# SERVICE BULLETIN

Classification: EM19-001	Reference: NTB19-003	Date: January 16, 2019
-----------------------------	-------------------------	---------------------------

## 2016-2017 TITAN XD DIESEL; HIGH PRESSURE FUEL INJECTOR SUPPLY LINE TORQUE CHANGE

**APPLIED VEHICLES:** 2016-2017 Titan XD (A61)  
**APPLIED ENGINE:** Cummins 5.0L V8 Diesel

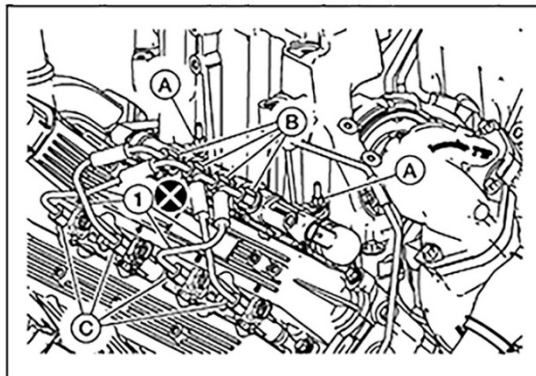
For the Applied Vehicles, the high pressure fuel injector supply line nut torque specification listed in the Electronic Service Manual (ESM) has been revised.

- (1) = Injector supply line (high pressure)
- (A) = Fuel rail bolt
- (B) and (C) = Injector supply line nut

**NOTE:**  
Bank 2 shown, Bank 1 similar.

Injector supply line nut (B)  
 Injector supply line nut (C)

Revised torque specification

: 40 N·m (4.1 kg-m, 30 ft-lb)  
 : 40 N·m (4.1 kg-m, 30 ft-lb)
